TECHNICAL BULLETIN DOC00039

We are aware of one model of PC Board with the potential of over-heating. This PC Board (Model 3230) was supplied to and installed on certain A&M Systems Door Headers manufactured from August 1, 2009 through March 31, 2010. Additionally, PC Boards that were field replaced during this time period could be affected and will need to be inspected. While these reports are few, the over-heating situation could cause the PC Board to burn in extreme cases. As a result we are sending this Technical Service Bulletin to help you identify and replace this PC Board.

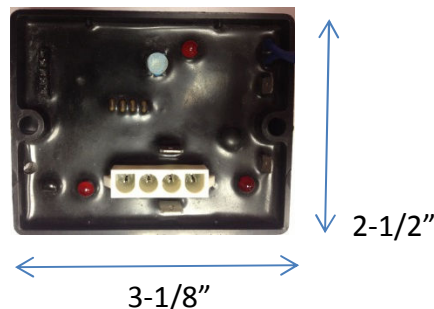
Only the Model 3230 PC Board has shown the potential to over-heat. Please be aware of the importance of this Technical Bulletin. Your prompt attention to this is highly recommended and should be completed no later than December 31, 2013.

1. Remove PC board from Header – PC Board is attached to Header plate with double face tape.
 - a. Unplug the four-pin connector feeding the board.
 - b. Unplug the blue wires from the open limit switch.
 - c. Remove the board by twisting and pulling the board off the header plate.
2. Remove the Information Label from the 3230 Model PC Board showing the 3230 Model number on the label.
3. **Record the following from the removed PC Board:**
 - a. **The scribed information from the outside edge of the board _____.**
 - b. **Header Model _____.**
 - c. **Header S/N _____.**
 - d. **Vehicle VIN _____.**
4. **Cut the two blue wires near the base and using the pre-addressed, postage paid enclosed envelope, send the label, the clipped wire harness and this form to:**

5. **Replace the existing fuse powering the PC Board with a 20 amp fuse.**
